# Access Compliance Report

## Public Rights-of-Way

Intersection ID: 49929	Main Street: ASHBOURNE_HALL_RD	Cross Street: CHAMBERLIN_RD	Location: SW
ADA ID: B57F7BDEAE9B	Ramp Type: Perp	Initial Pass/Fail: Fail	Overall Compliance: No
		Severity Score: 12.5

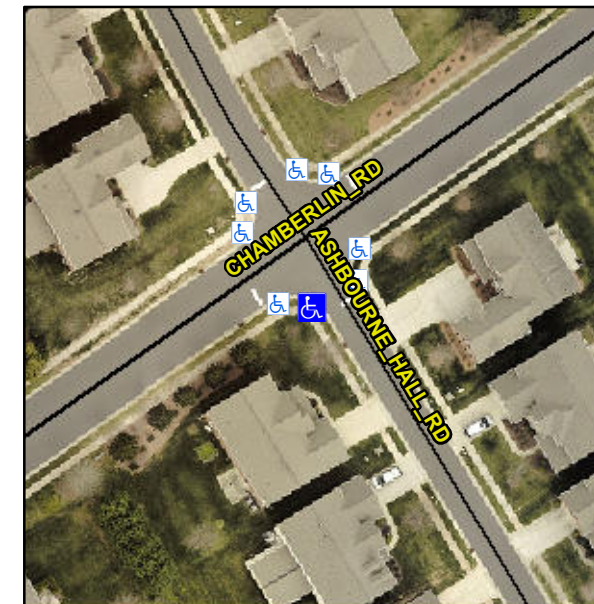
**Not Found, R304.5.3**

Compliance	Description	Data	Compliance	Description	Data
N/A	Ramp Length (in)	47.0	Yes	Ramp Slope (%)	7.5
Yes	Ramp Width (in)	48.0	No	Ramp XSlope (%)	6.1
N/A	Flare Type LT	N/A	N/A	Flare Type RT	N/A
N/A	Flare Slope LT (%)	N/A	N/A	Flare Slope RT (%)	N/A
N/A	Flare Traversable LT?	N/A	N/A	Flare Traversable RT?	N/A
N/A	Landing Length (in)	N/A	N/A	DWS Provided?	N/A
N/A	Landing Width (in)	N/A	N/A	DWS Contrast?	N/A
N/A	Landing Slope (%)	N/A	N/A	DWS Length (in)	N/A
N/A	Landing X Slope (%)	N/A	N/A	DWS Full Width?	N/A
N/A	Landing Curb? (Y/N)	N/A	N/A	DWS Offset (in)	N/A
N/A	Shared Landing?	N/A			
N/A	Gutter Ponding?	N/A	N/A	Gutter Slope (%)	N/A
N/A	Gutter Lip Ht (in)	N/A	N/A	Gutter X Slope (%)	N/A
N/A	Painted X Walk1?	No	N/A	Painted X Walk2?	N/A
	X Walk 1 Direction	To NE		X Walk 2 Direction	N/A
N/A	X Walk 1 Width (in)	N/A	N/A	X Walk 2 Width (in)	N/A
	X Walk 1 Slope (%)	1.3		X Walk 2 Slope (%)	N/A
	X Walk 1 X Slope (%)	5.2		X Walk 2 X Slope (%)	N/A

**Remove & Replace Entire Ramp.**
